Preliminary Site Inspection Report of Tower location nos. 282, 286 & 290 of 400 kV D/C Twin Moose Sambha – Amargarh Transmission Line of NRSS XXIX Transmission Limited ('NTL') in Rajouri district of Jammu on 17.11.2021

Fig 20

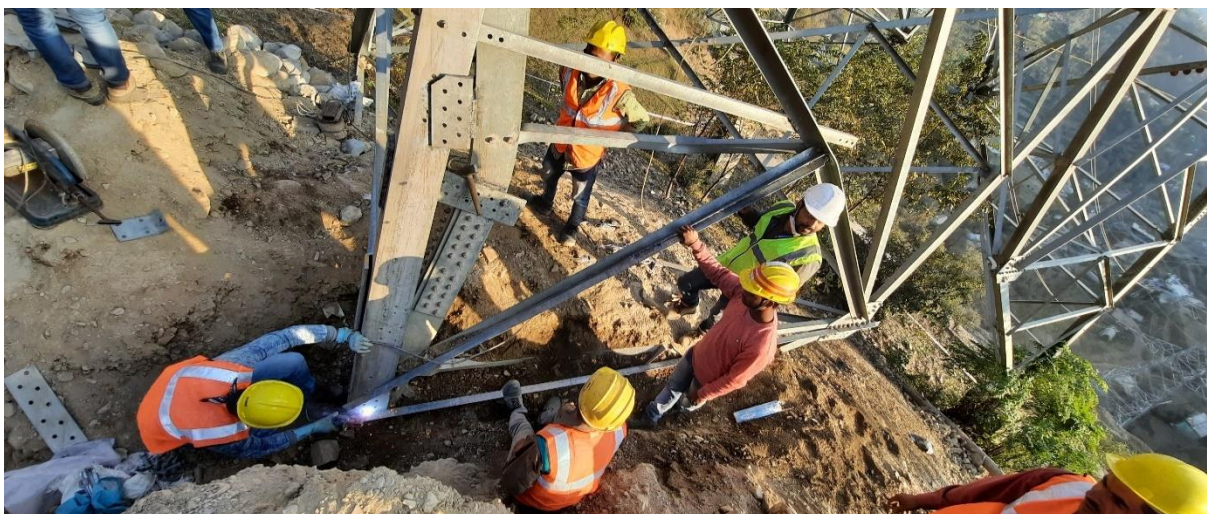
NTL have provided a temporary back stay to the tower to stop further buckling of the tower (Fig 19). Further, additional anchoring provisions (Fig 20) were kept at various critical points of hill slope and RCC reinforcement proposed for the breast wall. Also, stone pitching work is carried out around the tower to stop the soil erosion (Fig 21-23).

Fig 27

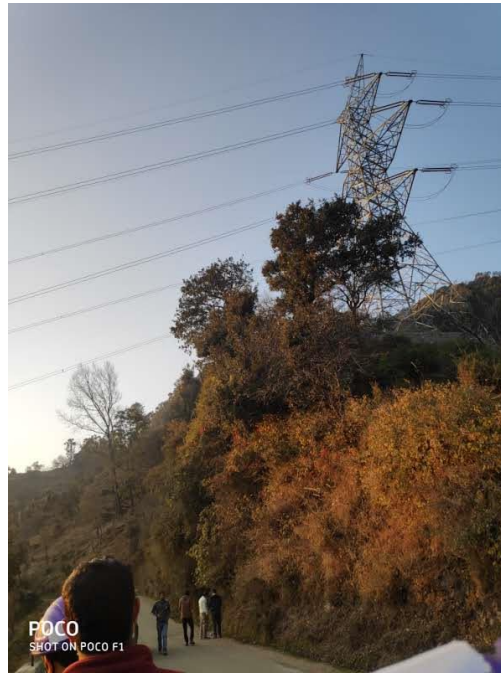
The tower is located on a steep hilly slope and very near to the road as shown in figure 27 and 28. It has been noticed that BRO has not started excavation work for widening of the road near this tower location. The tower is at high risk of collapsing when the excavation work will start. It is falling in the RoW of the proposed widened road. Proper steps are required to protect the hill slope before starting the excavation work.

5. At Tower Location 290, BRO has not started the construction of the road. The tower is very near to road and is located at a height. There is threat of tower collapsing if the excavation work is done near to subject tower location.
